RE: ADDITIONAL INFORMATION REQUESTED FOR THE MOORE RANCH
IN SITU URANIUM RECOVERY PROJECT LICENSE APPLICATION
ENVIRONMENTAL REPORT, FIRST SET OF RESPONSES

By letter dated March 23, 2009, the U.S. Nuclear Regulatory Commission (NRC) staff provided a request for additional information (RAI) to complete review of the license application Environmental Report for the Moore Ranch In Situ Uranium Recovery Project. By this letter, Energy Metals Corporation dba Uranium One Americas (Uranium One) is submitting the first set of responses to RAI. The attached response addresses the following topical areas identified by NRC Staff:

Question ER 2.5 No.1 Reasonable Alternatives – Alternate Plant Site

Figure 2.5-1

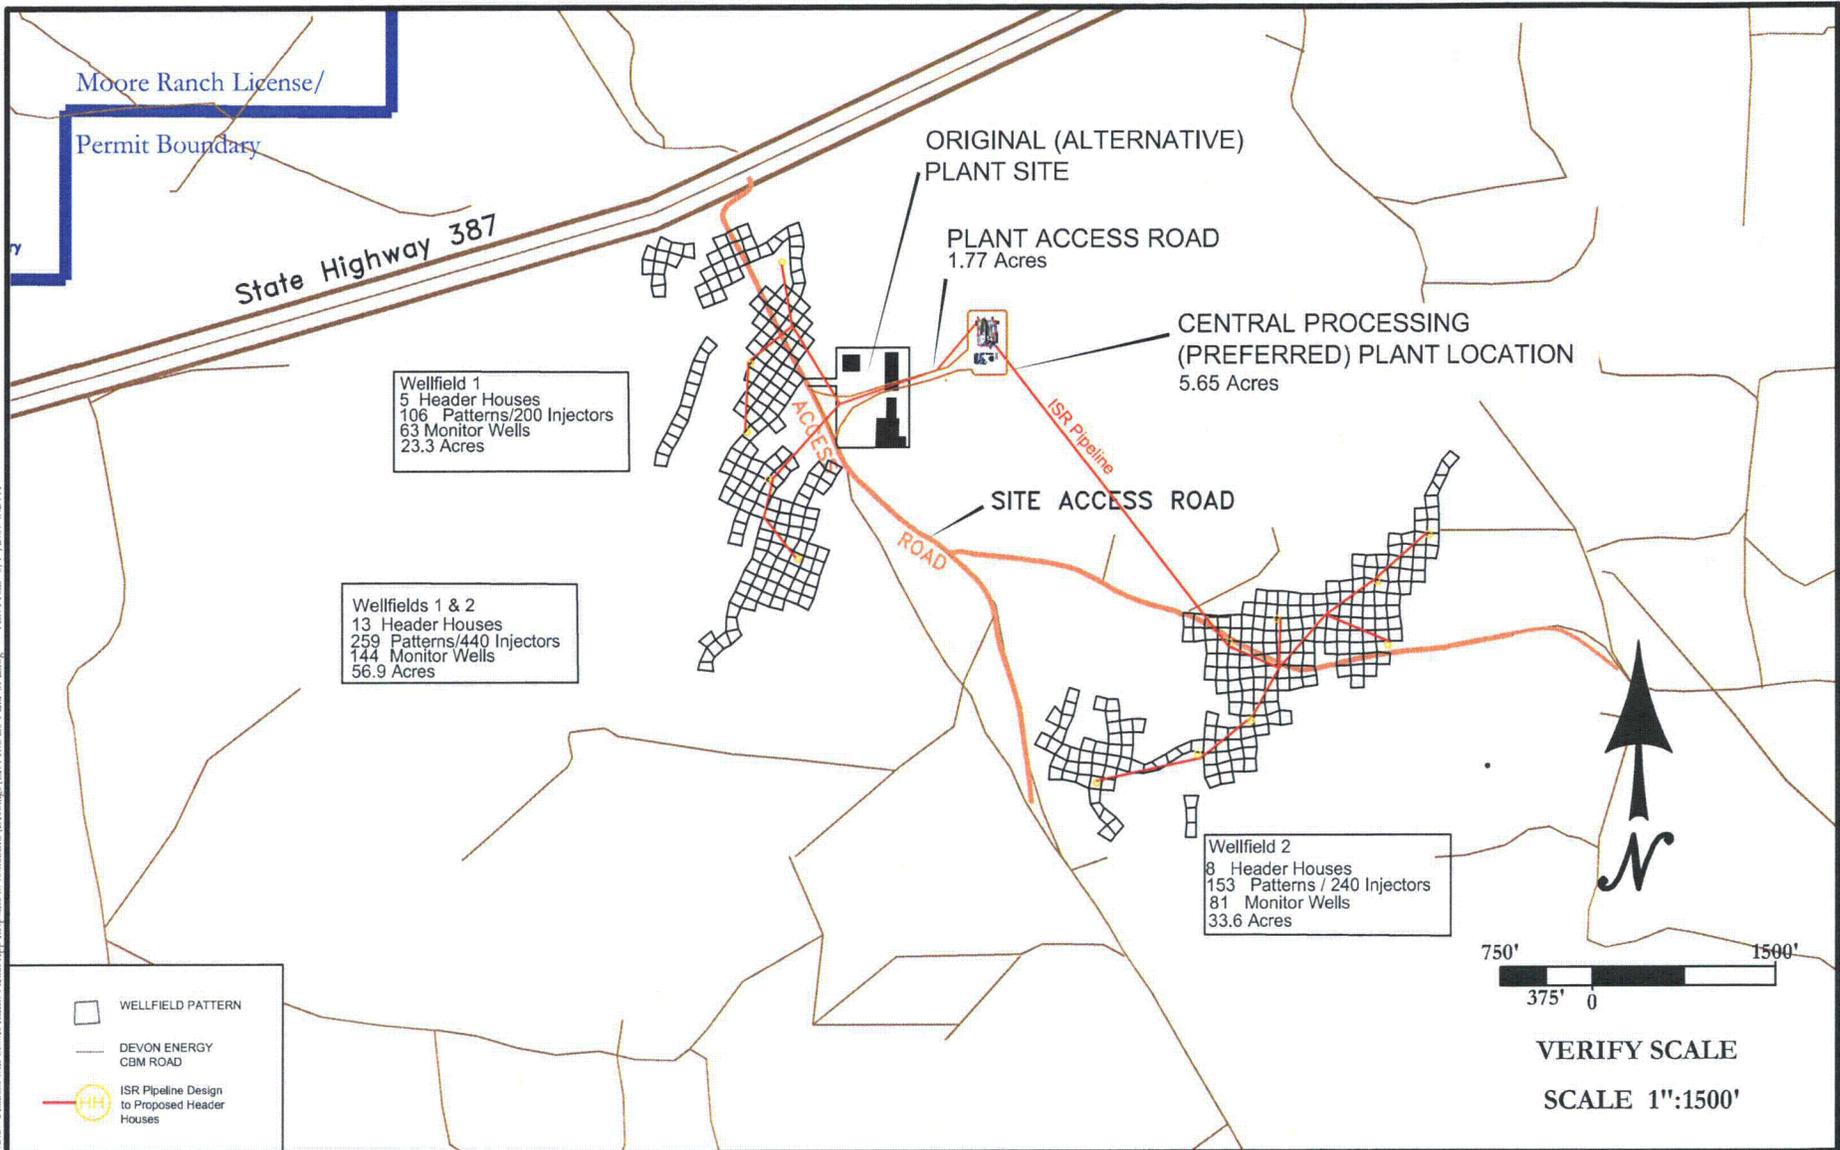
Information on other sites that were evaluated prior to picking the site where the project is to be accomplished. Also include information on the footprint, such as alternative plant locations, routes for roads, and building locations.

The Central Plant was initially proposed at a location which was situated approximately 700 feet to the west of the current proposed location, shown in Figure 1.2-4 of the Environmental Report. Since preparation of the Environmental Report, additional siting evaluations have been performed and a better location has been identified compared to the original proposed Central Plant site location. The current preferred Plant site is deemed the most suitable location primarily due to the existing topography and the minimal topographic changes required for the proposed layout of the plant infrastructure. Additional information on this evaluation and alternate site information including a new Figure 2.5-1 will be included in the revised Section 2.5 of this Environmental Report.

The site of the Moore Ranch Central Plant was initially planned at a location which was situated approximately 700 feet to the west of the current preferred location, shown in Figure 2.5-1. The current proposed plant site was deemed the more suitable location primarily due to existing topography, and the minimal topographic changes that would be required for the proposed layout to the plant infrastructure. The new proposed site location minimizes cut and fill, thereby minimizing the disturbance of natural ground. The revised site location, as with the alternate site location, is located to minimize environmental impacts in that it

will be in close proximity to the primary access road, it will avoid existing utilities, and its visibility from Highway 387 will be minimized.

Figure 4.2-1
MOORE RANCH URANIUM PROJECT
 Local Highways

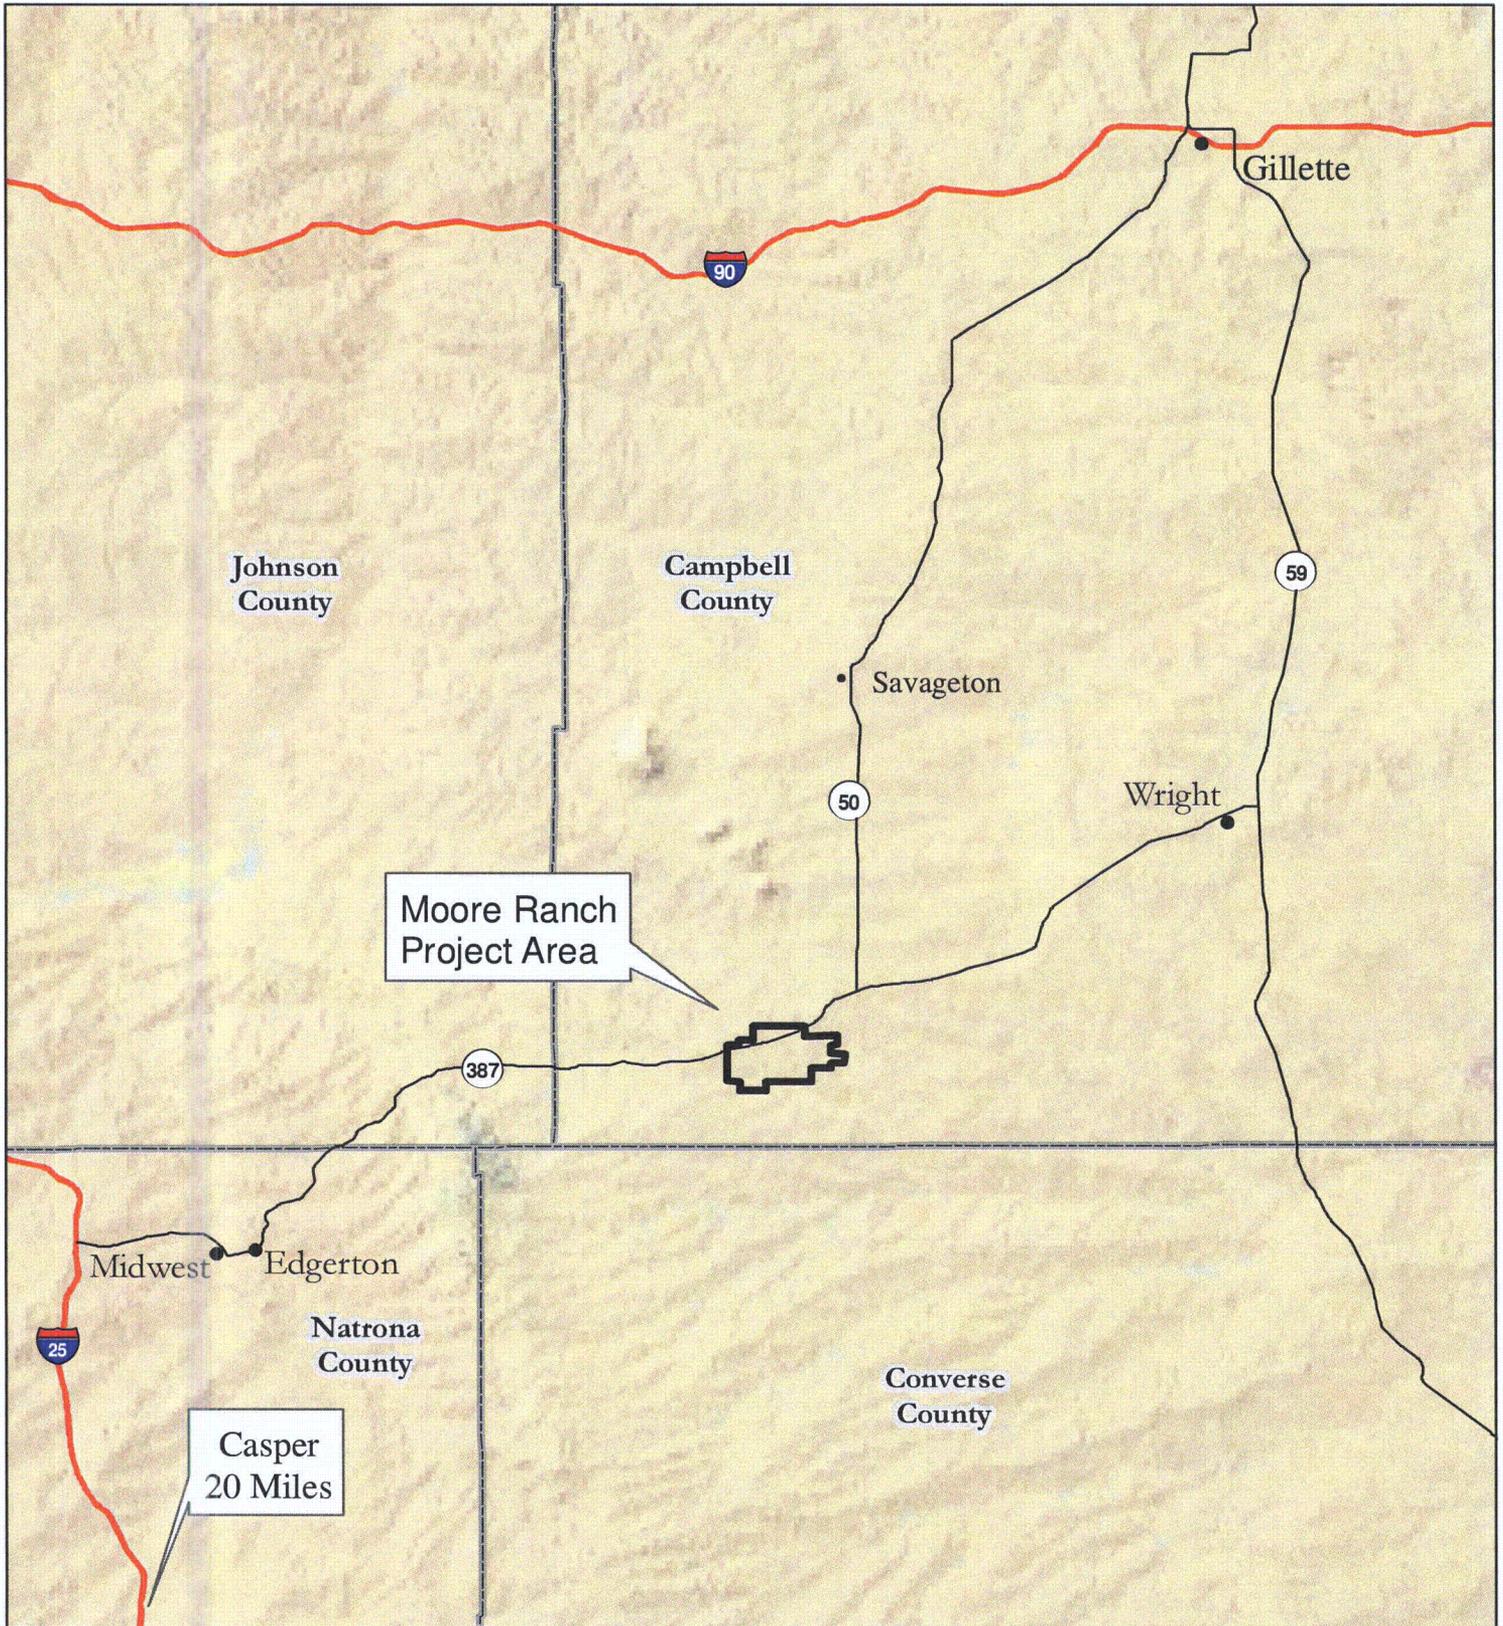
Please provide existing daily or peak hour traffic volumes and truck percentages on any of the local roadways to be utilized by daily activities at the proposed facility.

Average daily traffic volumes for the local highways in the project area, State Highways 50, 59 and 387 are shown in Table 4.2-1 (WYDOT, 2009). The traffic information includes data from years 1997, 2006 and 2007, and breaks down the truck traffic by percentage of the total traffic volume recorded in 2007. A map of the subject and regional roadways and communities is shown in Figure 4.2-1.

**Figure
4.2-2**

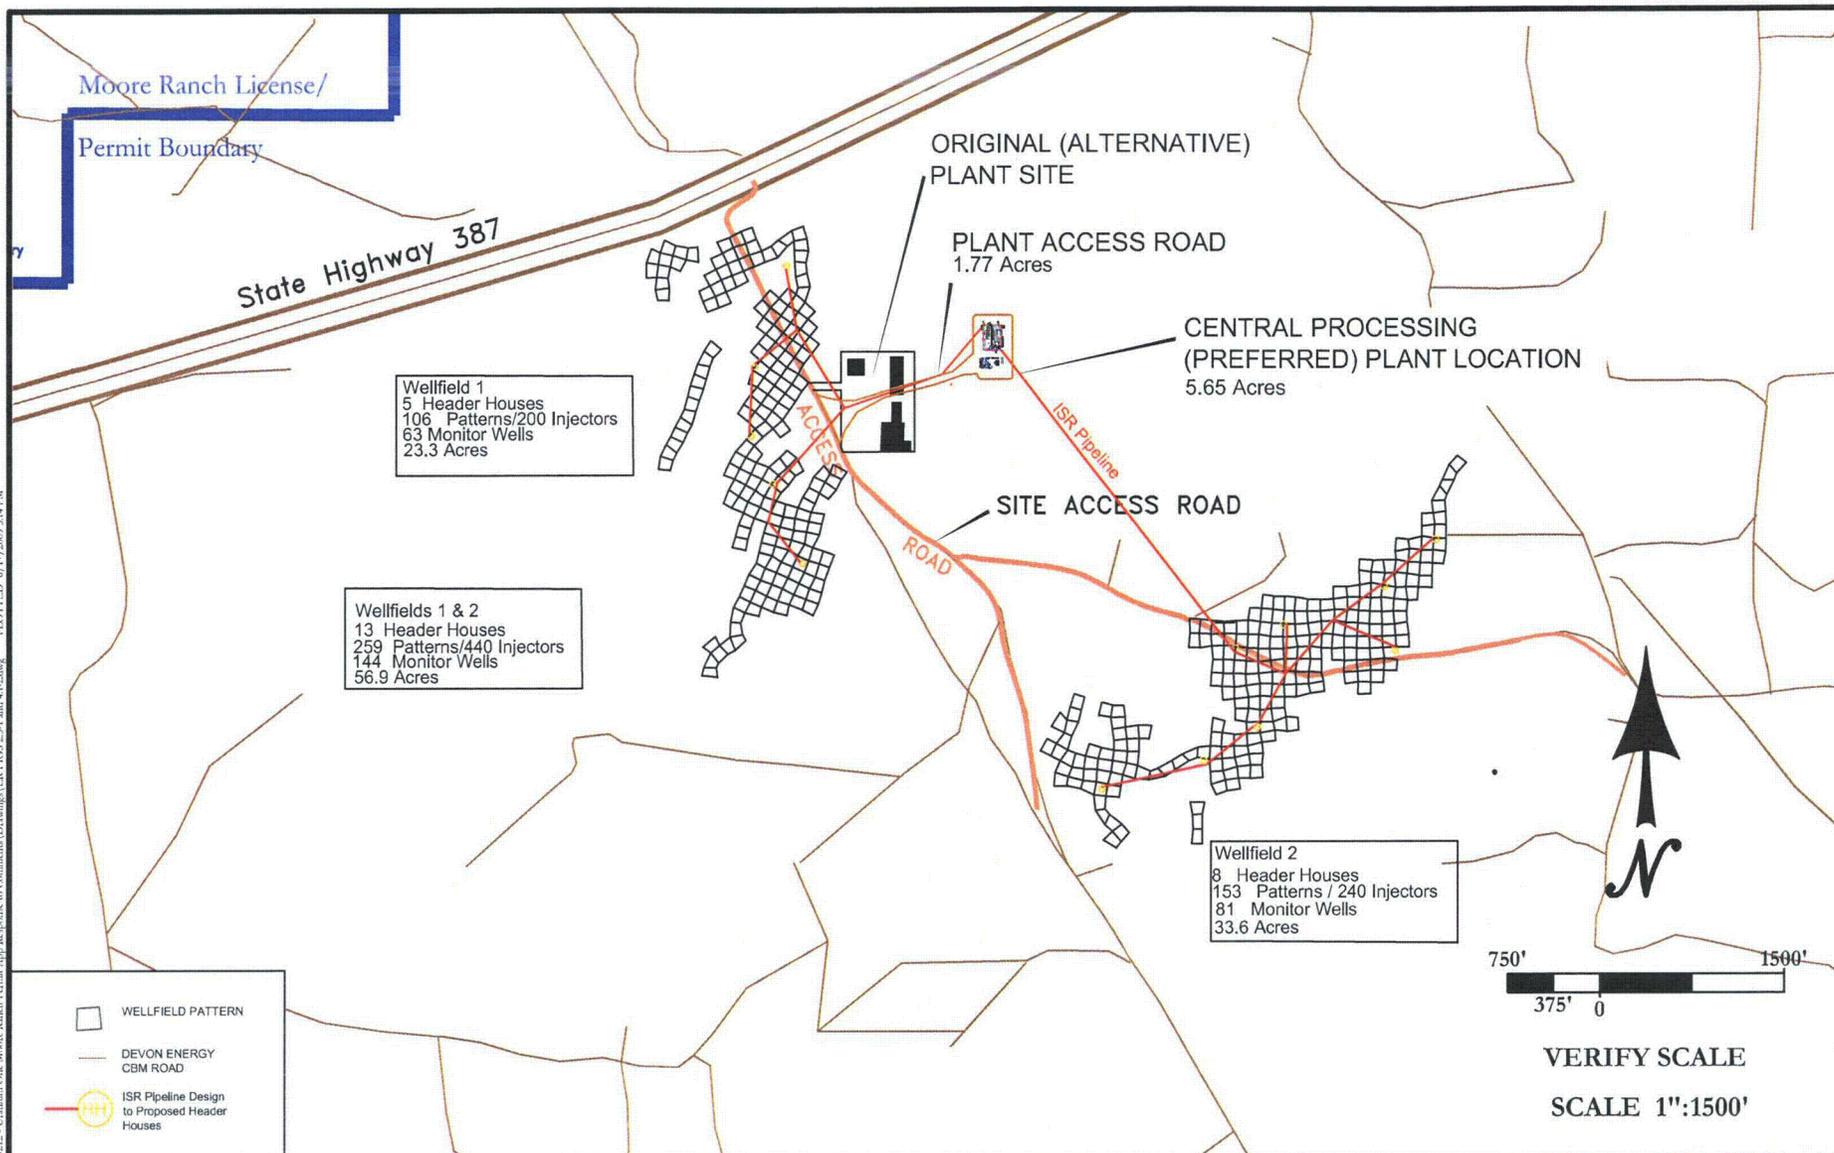
RAI Question:

All wellfield roads will be removed at the time of project decommissioning. The newly constructed gravel road that leads to the Central Plant from the main access road (shown in Figure 4.2-2) will be left in place for future use. This information will be added to the land use impacts analysis contained in Section 4.1 of this Environmental Report.

All wellfield roads will be removed at the time of project decommissioning. The newly constructed gravel road that leads to the Central Plant from the main access road (shown in Figure 4.2-2) will be left in place for future use.

Figure 3.7-1 Outdoor Day-Night Sound Level in dB at Various Locations

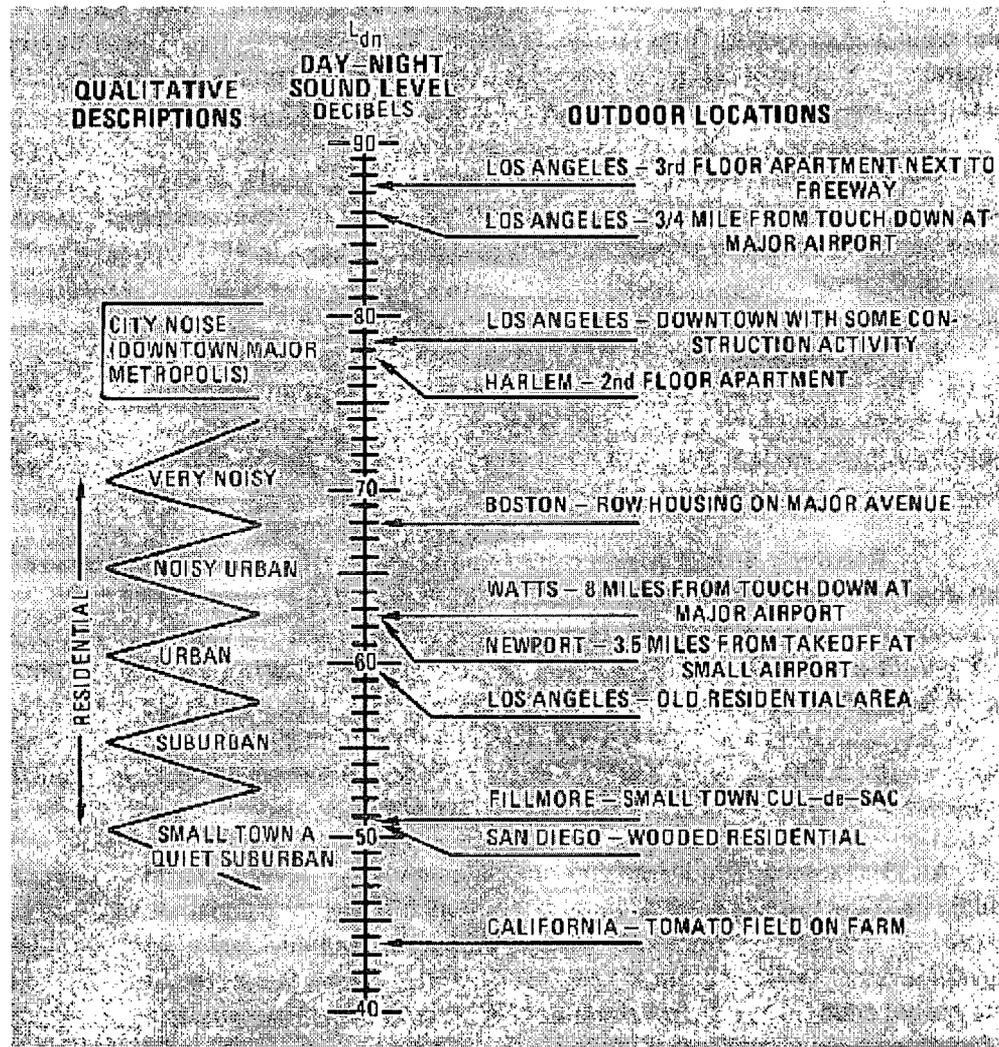
The ER states existing ambient noise in vicinity of the Moore Ranch Project area is dominated by traffic noise from State Highway 387, surrounding oil and gas operations, and on-site coal bed methane operations. However, it does not provide existing ambient background sound levels. Additional information is required to adequately characterize the existing environment.

- 1) Please provide any sound level measurement data to determine background existing sound levels.
- 2) If no field measurements were taken please provide the methodology of how the ambient background sound levels were determined for comparing future noise impacts after the project commences.

corridors is generally 30 to 40 dBA when the wind speeds are low. Background noise levels for the EPA category "farm in valley" are: daytime, 29 dBA; evening, 39 dBA; and nighttime, 32 dBA. Local conditions, such as topography and frequent high winds, can alter background noise conditions. The measured range of values of day-night sound levels outside dwelling units extends from 44 dB on a farm to 88.8 dB outside an apartment located adjacent to a freeway. Some examples of these data are summarized in Figure 3.7-1 (EPA 1974, EPA 1973).

Figure 7.1-1 Outdoor Day-Night Sound Level in dB at Various Locations

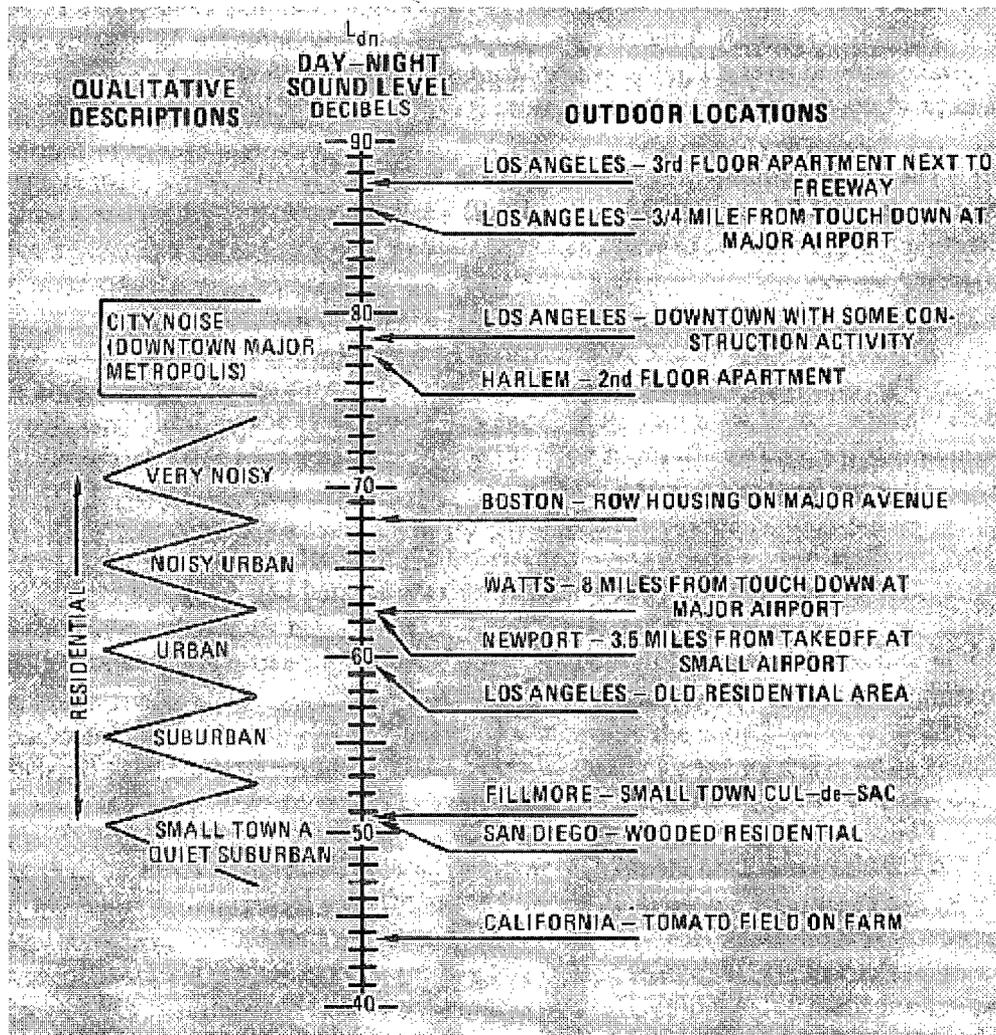
The ER, again, states that there will be no noise or congestion impacts within a two-mile area. However, it does not provide any projections due to construction activities associated with the proposed project. Additional information is required to adequately assess the noise impact of the project.

1. Please provide projections of typical machinery to be used at the project and the reference sound levels associated with construction activities.
2. Please provide projected truck traffic associated with construction on the roadways leading to the proposed facility.

Figure 7.1-2 shows the maximum noise levels anticipated at the Moore Ranch site during the construction phase of the project. Noise levels at the Project site boundary could be as high as 80dB at times during construction. However this construction activity sound level is less than or similar to vehicle traffic noise along HWY 387, and will not be a significant impact in the area.
